**North Donahue Widening Phase 1  
City of Auburn, Alabama**

**Addendum 1  
September 18, 2026**

**DONAHUE PHASE 1 WIDENING PROJECT  
MANDATORY PRE-BID MEETING SUMMARY  
SEPTEMBER 14, 2026**

| North Donahue Drive Widening Phase 1 Pre-Bid RFI's |                                                                                                                                                                                                                              |                                                                                                                                                                        |

| SHEET NO. | C4.1                   |

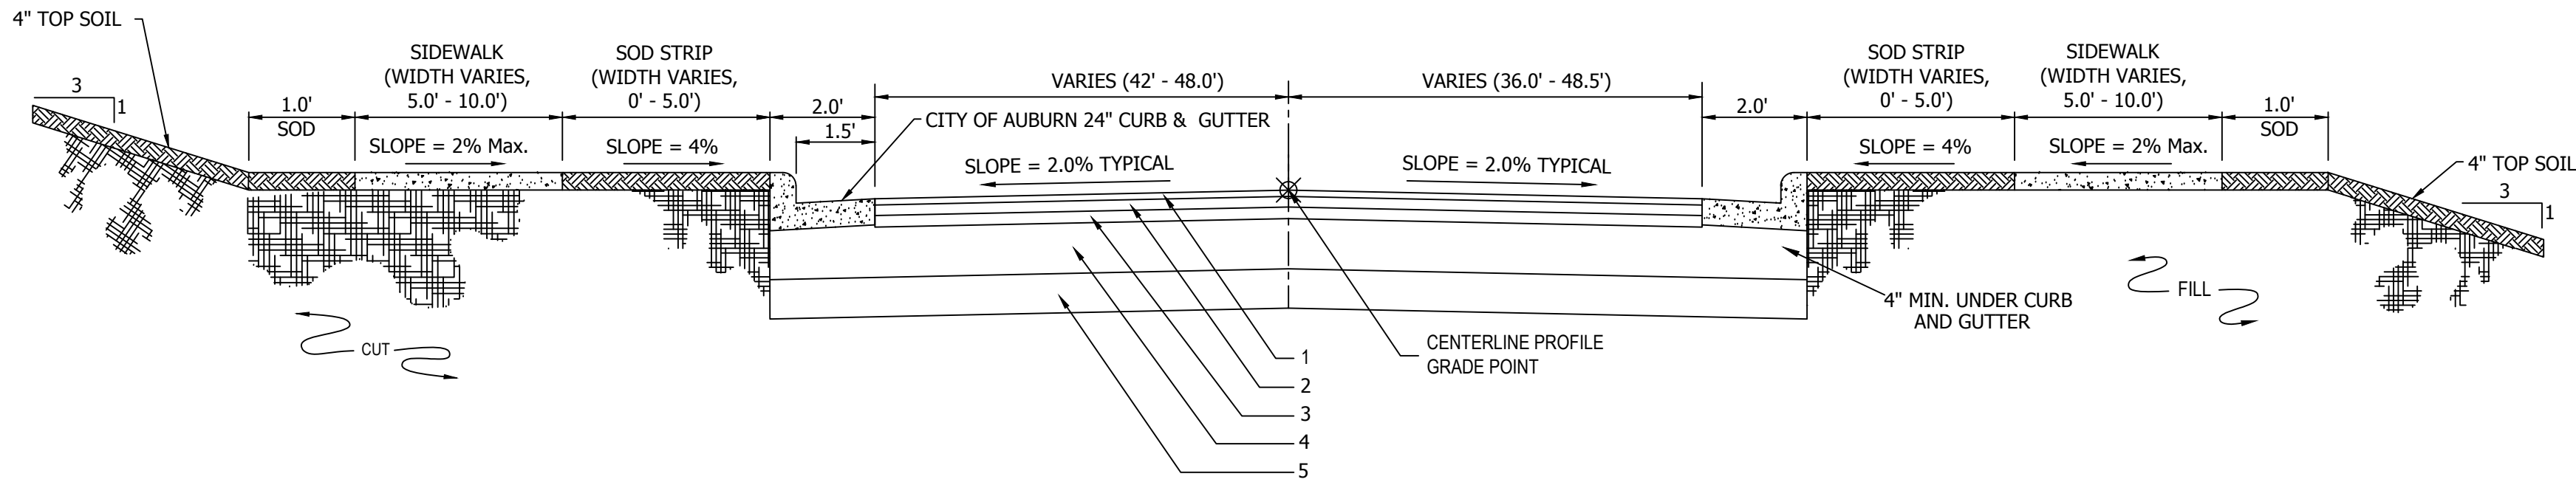
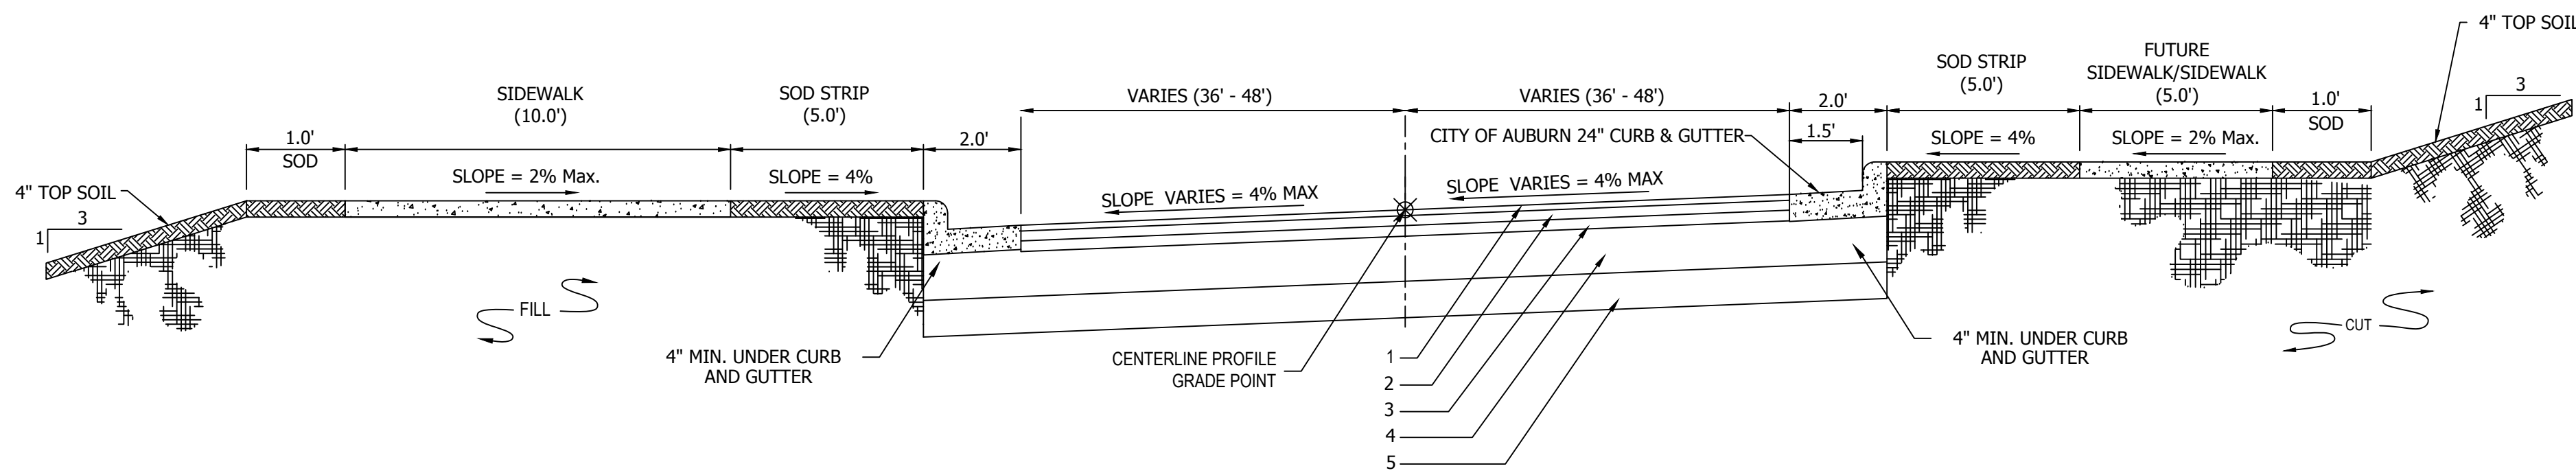
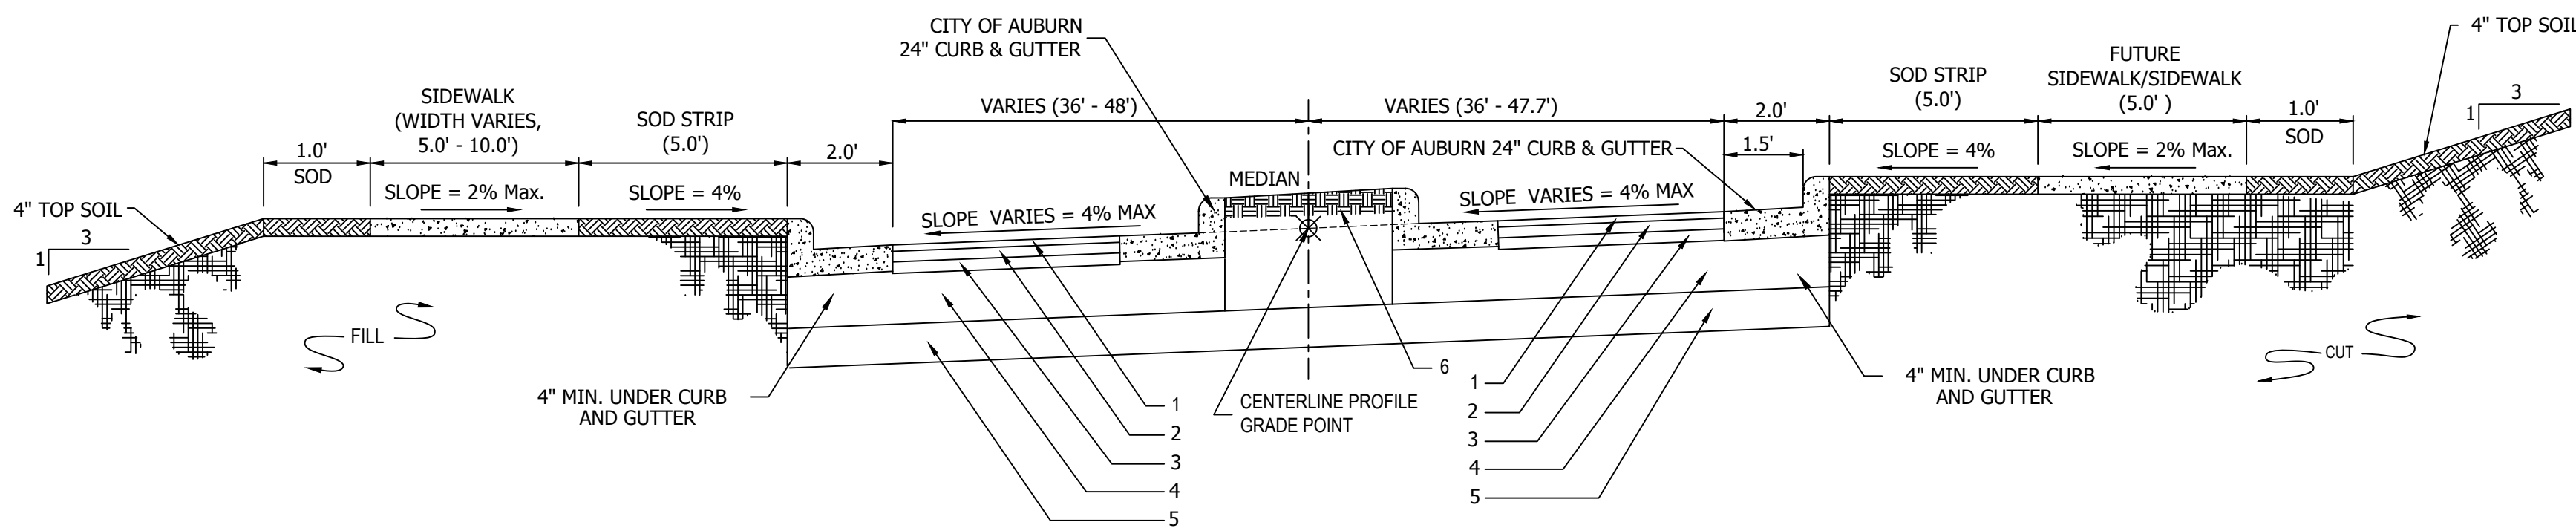
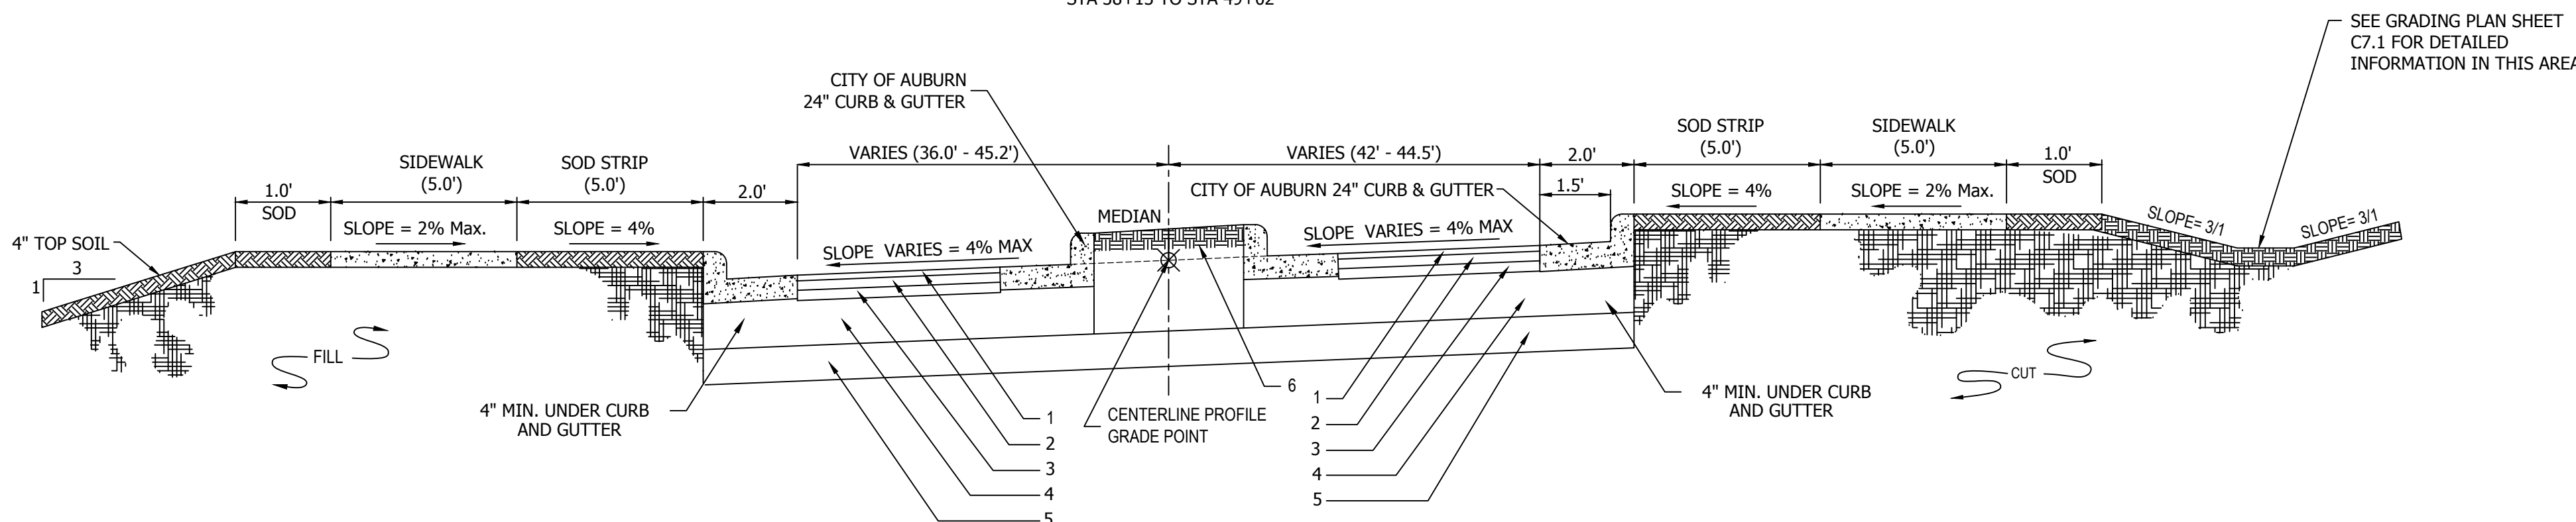
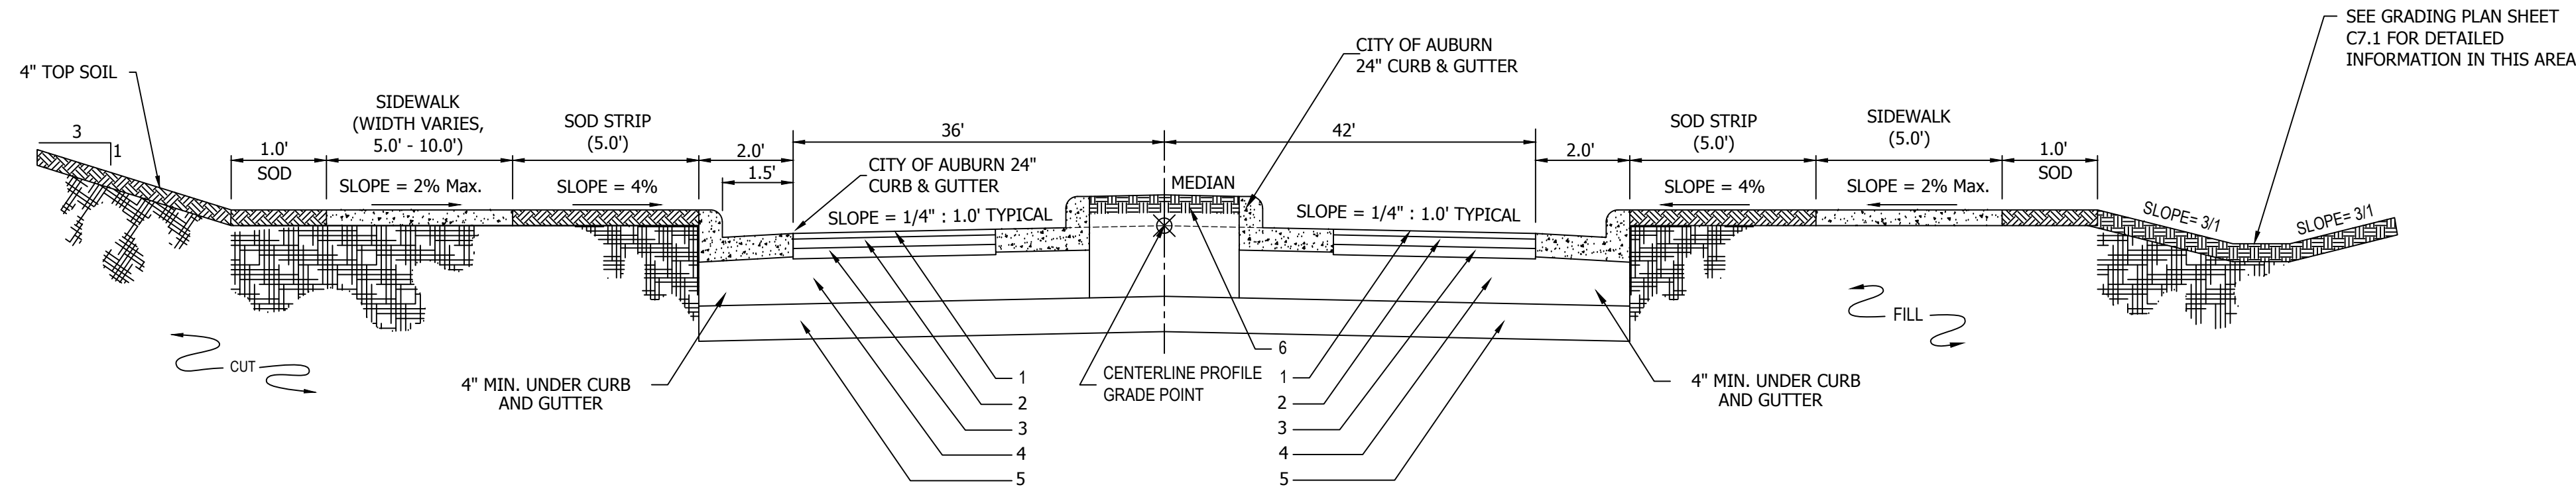
| North Donahue Drive Widening Phase 1 Pre-Bid RFI's |                                                                                                                                                                                                                              |                                                                                                                                                                        |
|----------------------------------------------------|------------------------------------------------------------------------------------------------------------------------------------------------------------------------------------------------------------------------------|------------------------------------------------------------------------------------------------------------------------------------------------------------------------|
| 9                                                  | The Typical sections note for "A" & "B" on pages C4.0 -C4.4 indicate the existing roadbase and pavement are to " plane and retain".<br>Please confirm the existing N Donahue Dr roadway is to be milled and overlaid per the | The station of transition from plane and retain to full depth has been revised on the typical section to match the plan view. The correct station is 12+85.            |
